HERITAGE PRESERVATION APPLICATION SUMMARY

Property Location: 121-125 Washington Avenue North
Project Name: The Washington
Prepared By: John Smoley, Ph.D., (612) 673-2830
Applicant: Preservation Design Works
Project Contact: Meghan Elliott
Ward: 3
Neighborhood: Downtown West
Request: To rehabilitate the buildings
Required Applications:

Certificate of Appropriateness	To rehabilitate the buildings
---------------------------------------	-------------------------------

Figure 1: Image of signage at 125 Washington, 1883.

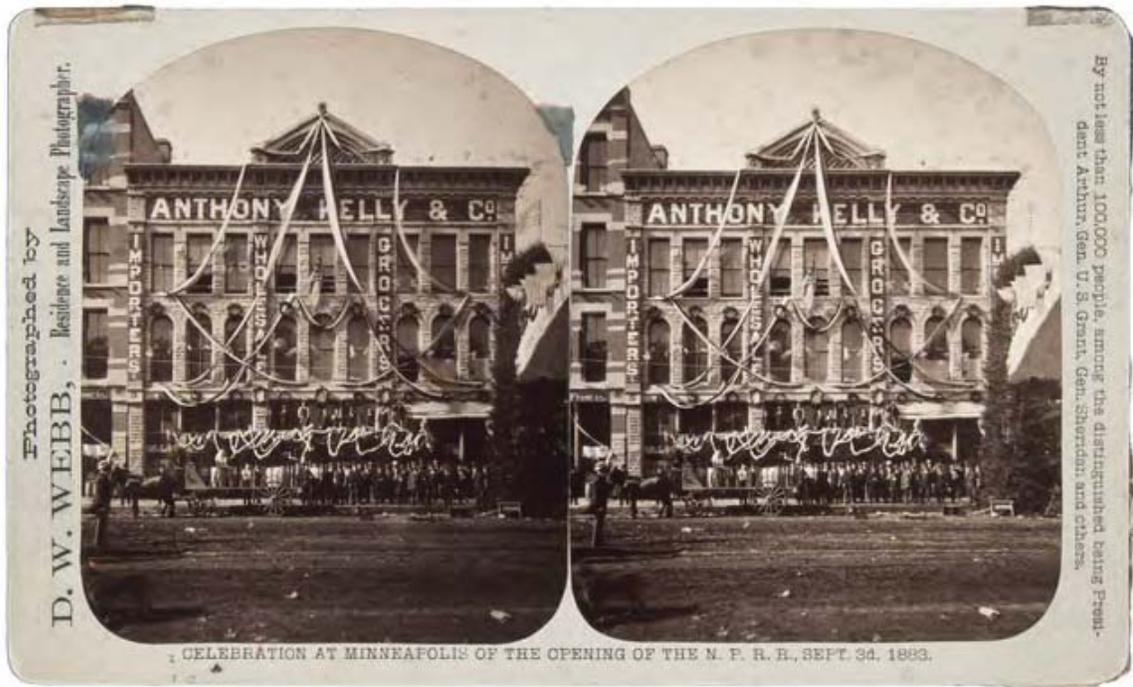
- iii. Historically, the building at 125 Washington Avenue North had vertical signage at each pilaster at the upper floors. (Four vertical signs existed along Washington Avenue North - IMPORTERS, WHOLESALER, GROCERS, and IMPORTERS – as shown in figure 1, below. Additional vertical signs may have existed along 2nd Avenue North.) The historic signage also exceeded the height of the current proposal and zoning code: the top of the vertical signs

was aligned with the top of the window openings. The proposed vertical signage – “The Washington” - is in keeping with historic precedents and the historic signage of the building during the period of significance of the warehouse district. See attached figure 1.

Drawn by: A303
Scale: As Indicated

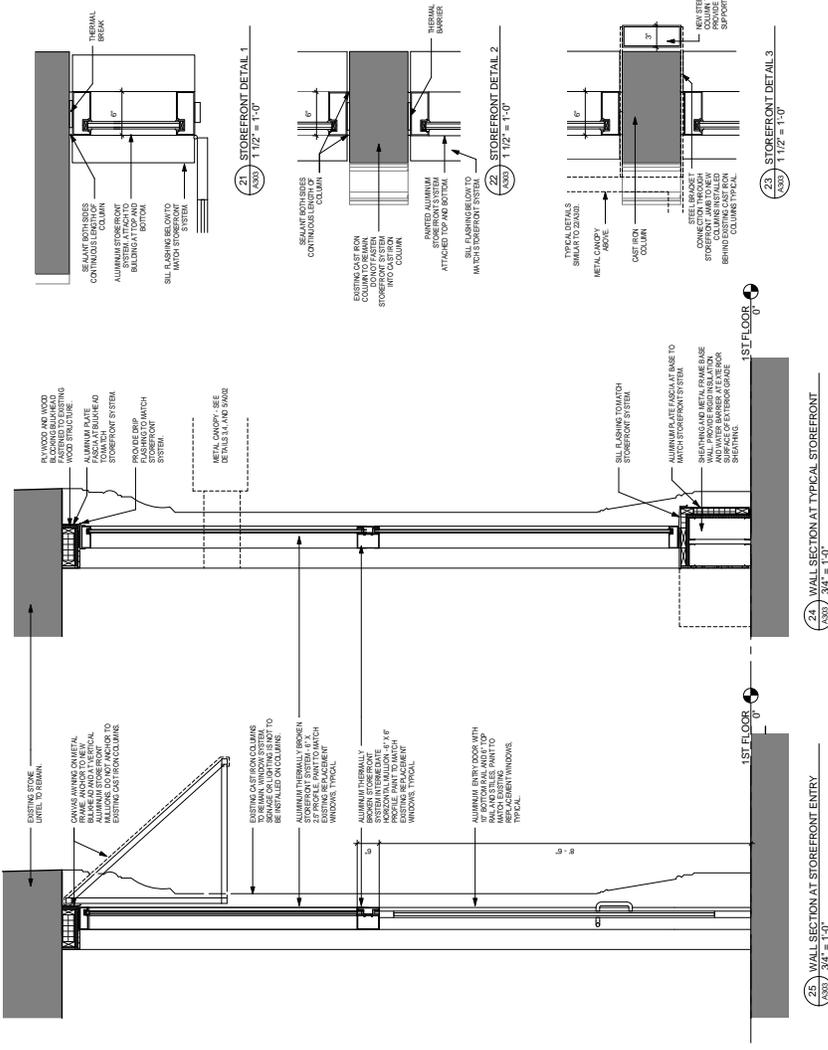
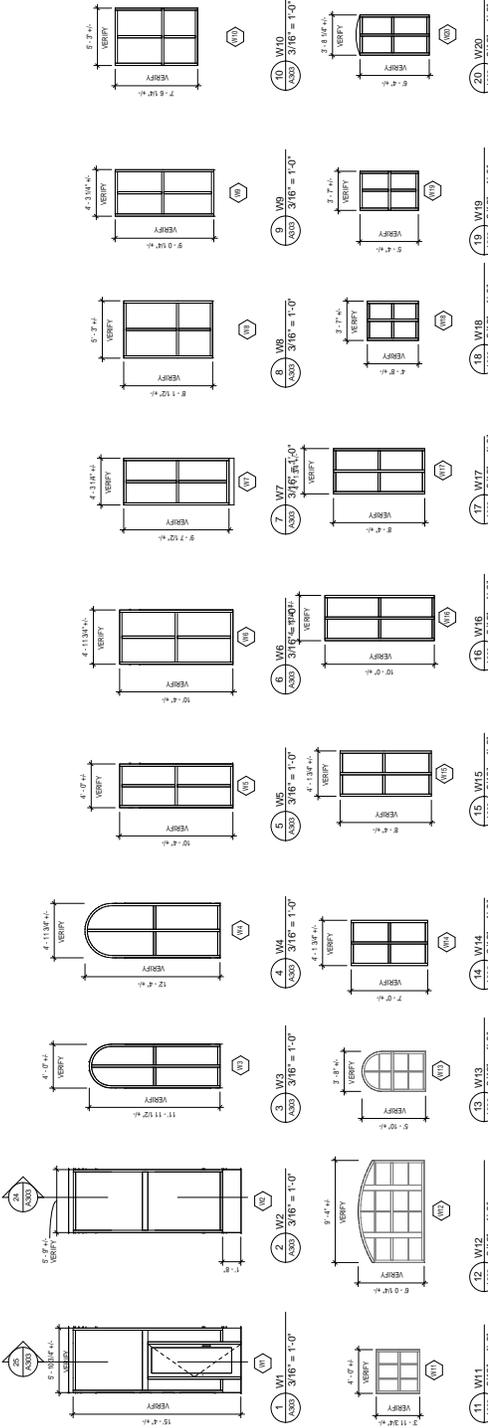
Minneapolis Warehouse Historic District design guideline 2.23 requires clear transparent glass be used in window and storefront replacements, with low emission coatings also being permitted if they are not reflective or tinted. Since the plans do not specify this level of detail, staff recommends the project be conditioned to ensure this standard is met.

- a. The proposed storefront is described on sheet A303, and illustrated on sheet A302. The storefront door and panel types are windows W1 and W2 (1 and 2/A303). Additional details are shown in details 21 through 25/A303. The storefront is designed to fit within the existing cast iron columns, header beam, and base of the building at 121 Washington Avenue North, and within the existing stone pilasters, header beam, and base of the building at 125 Washington Avenue North. The new storefront will also be installed in some of the bays along 2nd Avenue North. The proposed storefront replaces non-historic storefront materials at the 121 building, as well as inappropriate block infill along Washington Avenue North and Second Avenue North. The storefront design is based on historic photographs of the Washington Avenue façade (see figure 2, below).

- c. Detail 25 on sheet A303 shows the proposed fabric awning system and attachment to the new storefront. To minimize damage to historic materials, the awnings are supported on the new storefront mullions.

- a. Sheet A303, W13 has been revised to show a 4/4 division of lights.
- b. Existing windows are documented in the window survey, pages 60-76, and replicated in the window schedule in sheet A303.
- c. Replacement windows do not include any optional “features.”
- d. The storefront and replacement windows will be painted to match the existing historic windows, generally a dark brown.
- e. All renderings on sheet A303 have been revised to note the correct division of lights proposed for all windows.

4 Elevation West
 A301 1/16" = 1'-0"

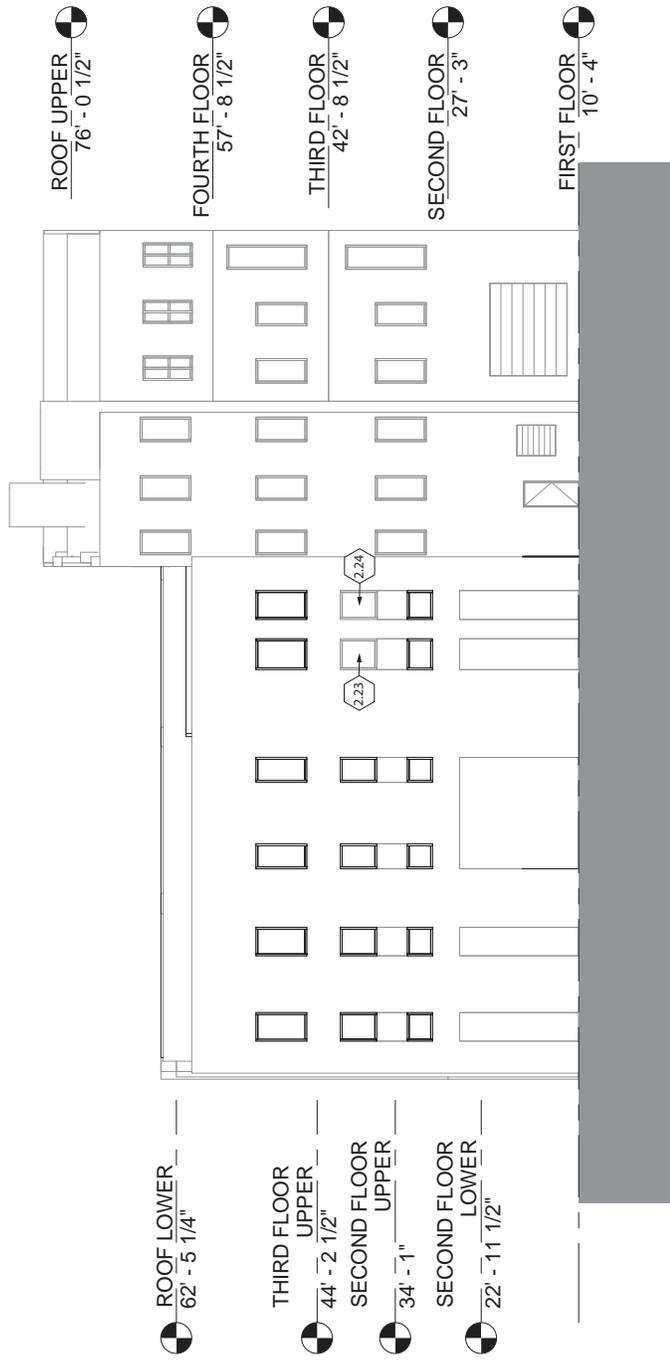
- a. The roof deck access door (formerly note 311, west elevation, sheet A301) has been eliminated from this phase of the project. The rear access alley door (note 311, east elevation, 4/A301) is required to meet municipal building code requirements for egress as follows:

- b. The roof deck access door (formerly note 311, west elevation, sheet A301) has been eliminated from this phase of the project.
- c. The rear access door at the alley (note 311, east elevation, 4/A301) will be a commercial style 8'-0" hollow metal frame & insulated steel door. Note D04 on A103 instructs that new openings be supported with steel lintels placed in existing masonry joints to minimize damage to existing brick units. The note further instructs "Historic bricks removed in the course of preparing new openings in existing walls are to be salvaged and stored on-site."
